INDESIT company

Model type:
AMXXL129EU

Commercial code:
F037726

n1040398: Programme keys aligned.

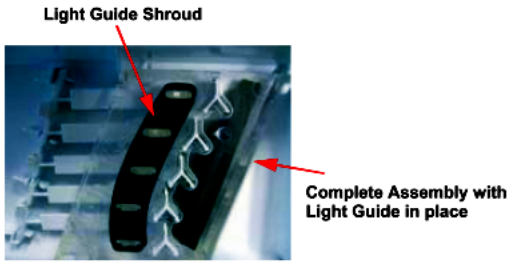
From serial no. 51118.0001, a specially shaped foam pad has been inserted between the keypad and light guide on washing machines AVXXF and AVXXL and washer-dryers AMFFX and AMXXL. The part code of this new component is C00142393 (fig. 001).

This new part separates the keys and pushes them outwards together to ensure they are perfectly aligned.

The pictures in figures 002 and 003 illustrate how the foam pad should be fitted on the keypad and subsequent assembly of the light guide with relative light guide bracket, code C00142648.

The new parts C00142393 and C00142648 can also be used on premodification appliances.

n0508c01: Door Gasket Clamp Band

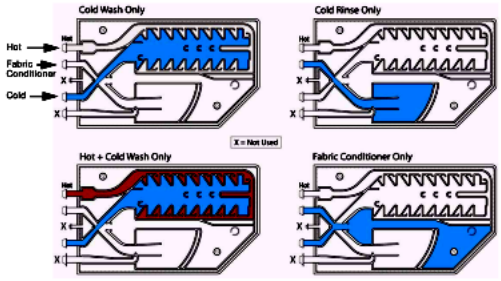
A New Polypropylene Gasket clamp band has been introduced in production from Serial number 80325.0000
The purpose is to provide added support to the inner rim of the door gasket.
